# Anupam Hosiery Industry (Pvt.) Ltd. (Steel Shed)

Vulta, Rupgonj, Narayangonj  
(23.77472, 90.56012)  
13<sup>th</sup> February 2022

Steel Shed: Single storied steel Shed.

Compression Strut – Marked location

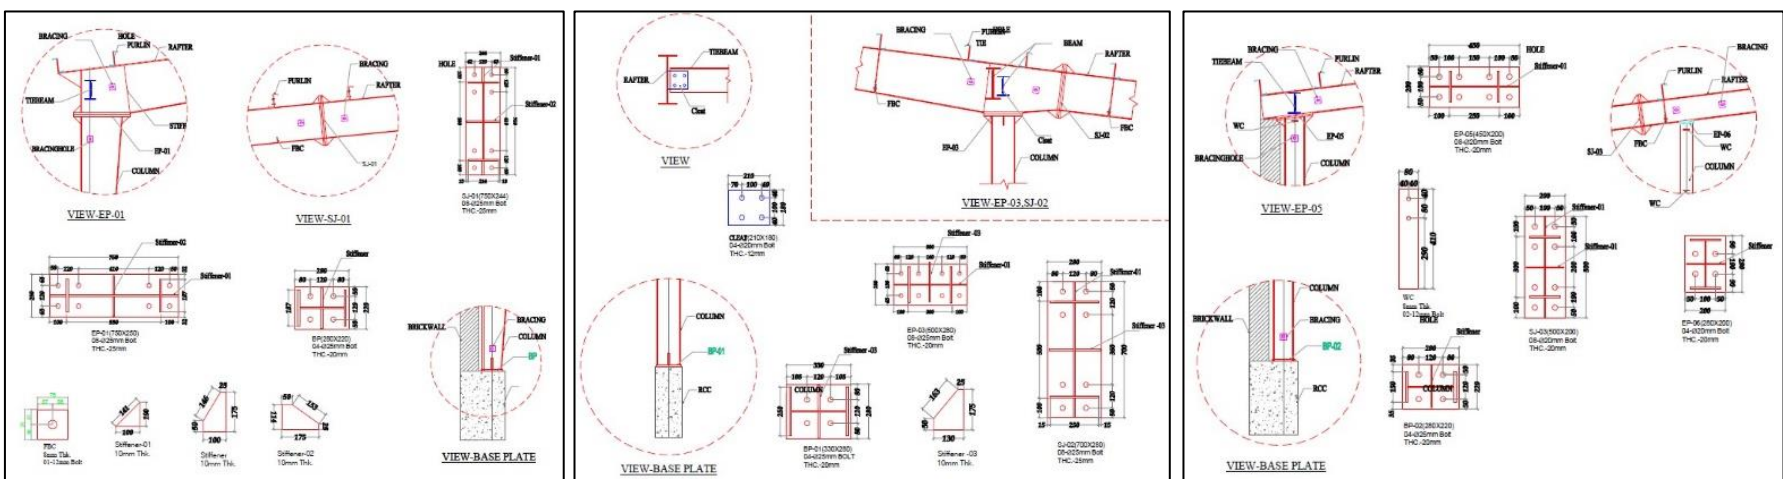
Cable Bracing size has not been shown in drawing which was found 12mm diameter

During inspection, bracing was not found at marked location as per as-built drawing. Factory engineer is required to develop the accurate as built drawing and submit to RSC for further review.

During inspection, compression strut was found at site. But in as-built drawing, the compression strut section details has not been provided. The size was found W250(8)XF150(10).
